Council Meeting

Item Number:	ORD12
Subject:	POST-EXHIBITION ASSESSMENT OF PLANNING PROPOSAL & VOLUNTARY PLANNING AGREEMENT FOR 152-206 ROCKY POINT ROAD, KOGARAH (FORMER DARRELL LEA SITE)
File Number:	F13/274
Report by:	Manager Place Outcomes (Erika Pawley)
Contributors:	Urban Strategist (Josh Ford) Strategic Asset Planner (Albert Jean)
Community Engagement:	Yes
Financial Implications:	No

Item Number: ORD09
Subject: ASSESSMENT OF 152-206 ROCKY POINT ROAD, KOGARAH (DARRELL LEA SITE) PLANNING PROPOSAL
File Number: F13/274
Report by: Coordinator Urban Strategy (Jacky Wilkes)
Community Engagement: Yes
Financial Implications: No

Figure C - Proposed height changes to RLEP 2011 (revised planning proposal)

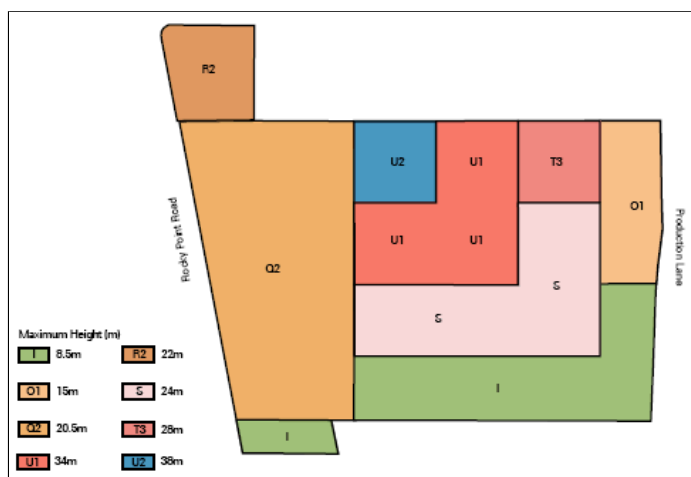
Figure 15 in the revised planning proposal illustrates the proposed height changes to the Building Heights Map. However, there is inconsistency with the descriptions at Table 2 (p.14) in the planning proposal. These heights in the Table 2 state:

- 38 metres in the north-western corner,
- 34 metres immediately south west of the 38 metre height,
- 28 metres in the northern part of the site,
- 24 metres immediately south west of the 34 metre height,
- 15 metres fronting a portion of Production Avenue,
- 8.5 metres fronting the remaining portion of Production Avenue and the southern boundary of the site proposed to be zoned R4.

An extract from the revised planning proposal (Figure C below) shows the proposed building heights across the site.

Figure D - Proposed height changes to RLEP 2011 (August planning proposal)

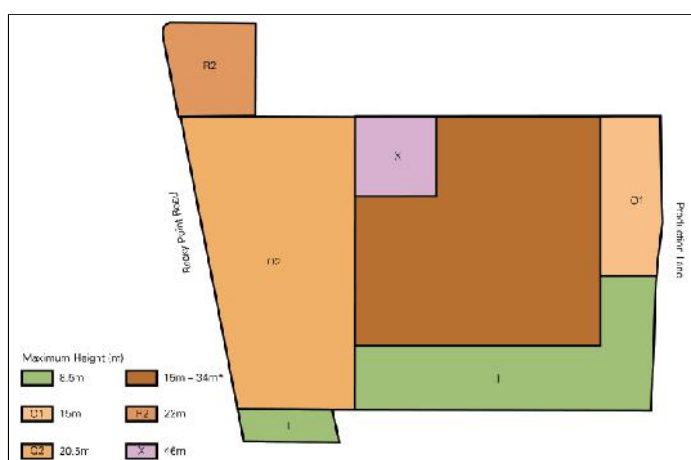
As stated, these heights vary from the heights proposed in the planning proposal submitted to Council on 30 August 2013, which is provided in Figure D, below.

The differences in height between the two proposals are:

Figure E - Proposed number of storeys

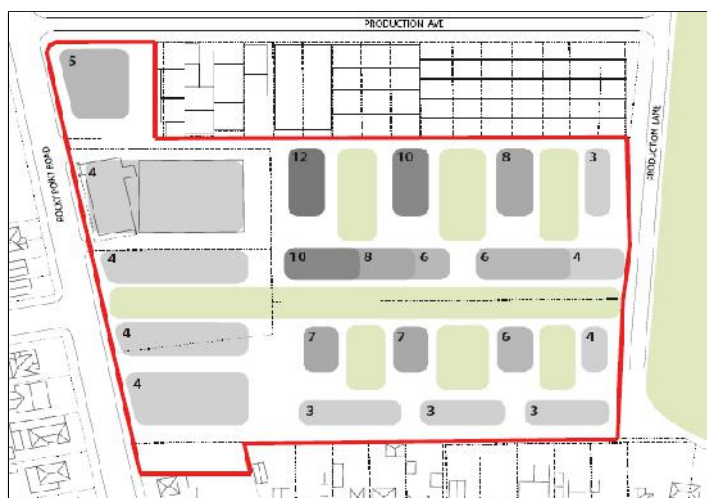
Despite these changes, the applicant's Urban Design Statement and supporting elevation drawings (refer to Attachment 2A to this report) have not been amended to reflect these changes. It means the urban design material submitted to the DP&I is identical to the material submitted earlier to Council on 30 August 2013. The accuracy of the plan drawings and elevations over the portion of the site that was coloured purple and dark brown (in the August proposal - as per figure immediately above) is in doubt.

Furthermore, Drawings 7 and 9 in Appendix B within the planning proposal, show heights stepping down (refer to Figure E above).

The height map also includes a notation "Final heights to be determined". However, an applicant must be clear on the proposed heights before lodgement of the planning proposal to Council for consideration.

Figure F - Proposed floor space ratios controls for RLEP 2011

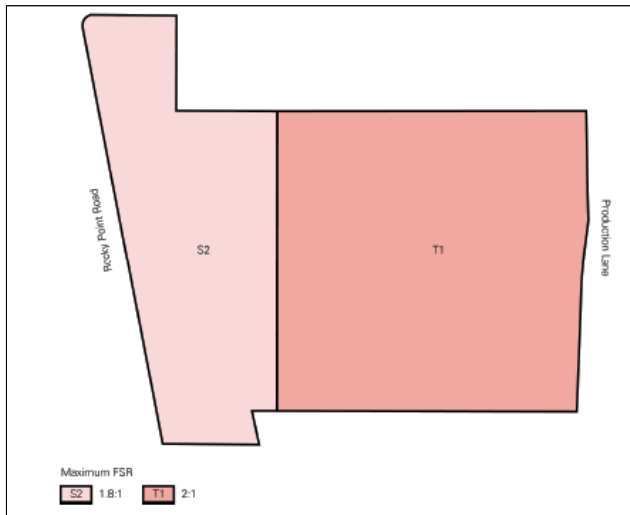
- FSR of 1.8:1 over the land proposed to be zoned B6 Business Enterprise.
- FSR of 2:1 over the land proposed to be zoned R4 High Density.

The proposed 2:1 FSR over land proposed to be zoned R4 is not illustrated in the applicant's Urban Design Statement (refer to Attachment 2A to this report) nor is it justified in the applicant's supporting elevation drawings (refer to Attachment 2B). The Urban Design analysis which support the planning proposal only tests a FSR of 1.83:1. This is evidenced by Drawing No. 8 Indicative Ground Plan (see Figure G below) the and confirmed by the applicant's architect. However, a 2:1 FSR is being sought by the applicant.

The documentation and urban design analysis submitted with the planning proposal illustrates a residential development scheme that achieves a FSR of 1.83:1. There is no explanation in the planning proposal of the rationale for a 2:1 FSR. It is noted, however, that the FSR in the nearby Ramsgate Small Village is 2:1 and this has been mentioned as the basis for the planning proposal.

Figure J - The applicant's proposed heights incorporating the number of storeys consistent with Rockdale DCP 2011

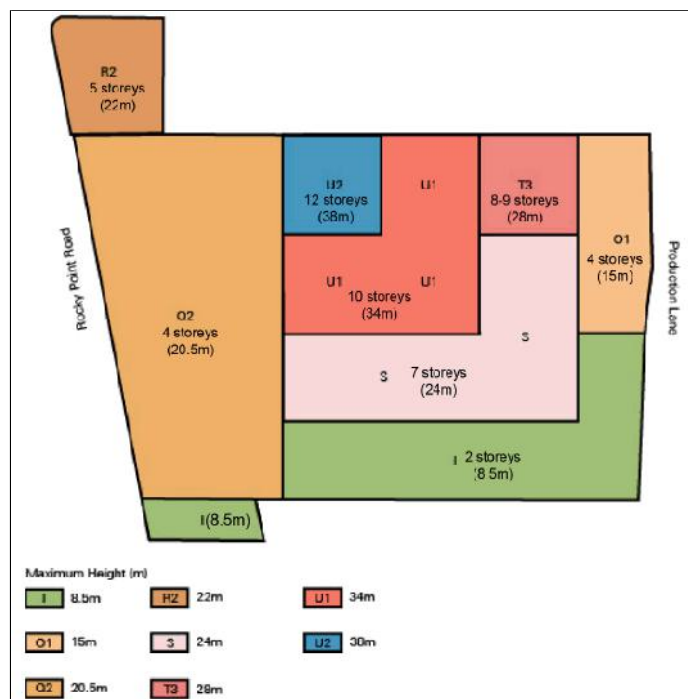
The applicant has sought to minimise the impact on surrounding residential properties by proposing a 6 metre landscaped buffer and a low density residential height limit of 8.5 metres along the southern (Margate Street) boundary. The proposed height limits then increases in 3 storey 'layers' (24m, 34m and 38m) travelling north. The height limits are also reduced toward Scarborough Park to the East. Refer to Figure J, below.

The applicant's aim is to enable the low density development to screen the higher density development until the distance from the southern (Margate Street) boundary is sufficient for the high rise development to have limited or no impact. When preparing the scheme the applicant has made note of the blank wall of the existing factory building although it is also worth noting that the existing factory building only extends two thirds of the way down the site and does not contain either windows or balconies.

As a result of this analysis, it is recommended that the proposed Building Height Map be amended to reflect the height limits illustrated in Figure L, below.

Figure K - Elevations showing sight lines

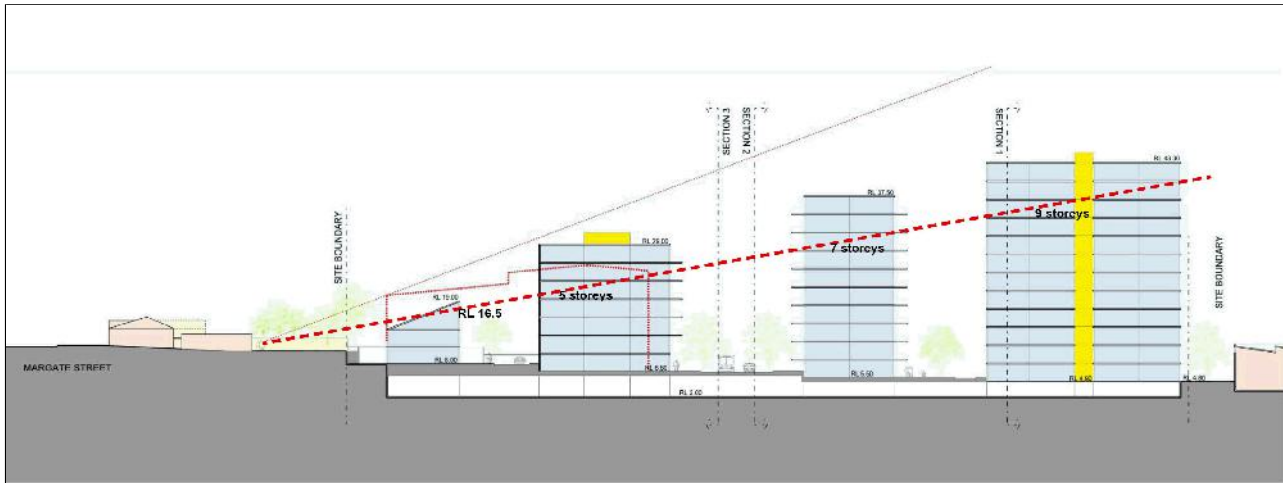
The height limits proposed by the applicant do not achieve this aim as illustrated by the (black) sight line in Figure K. The resulting development would be overbearing and would impact on the privacy of the neighbouring low density residential properties. Instead, it is recommended that the height limits be reduced as indicated by the (red) sight line in Figure K.

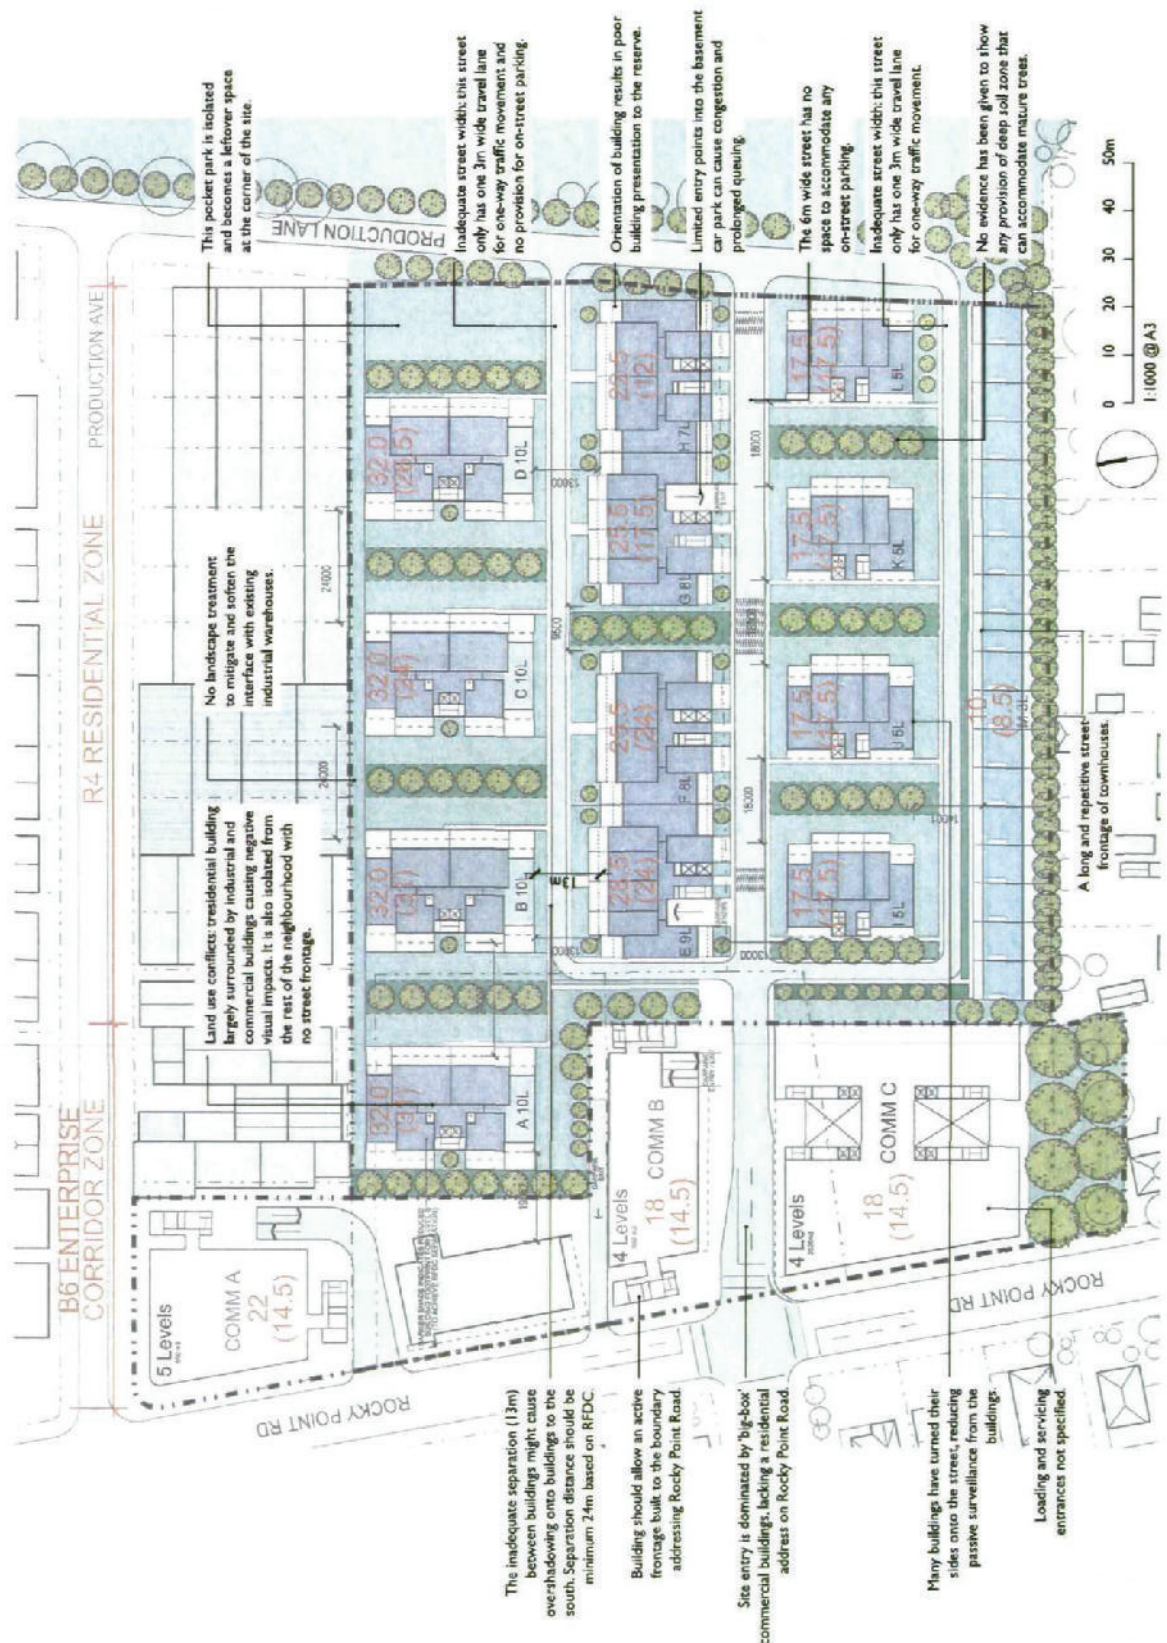
- There is a lack of landscape character with an absence of a comprehensive landscape strategy.

- In Option 2(b) Residential Buildings E, F, G and H might cause overshadowing to buildings located immediately to the south considering that only 13m building separation is given; this does not comply with the objectives and numerical controls recommended by the RFDG;
- In Option 2(b) there is a lack of adequate height transition to the east towards Leo Smith Reserve, considering that the buildings proposed immediately adjacent to the reserve are 7 storeys and 5 storeys high;
- Building COMM B does not have an active frontage built to the boundary to address Rocky Point Road.
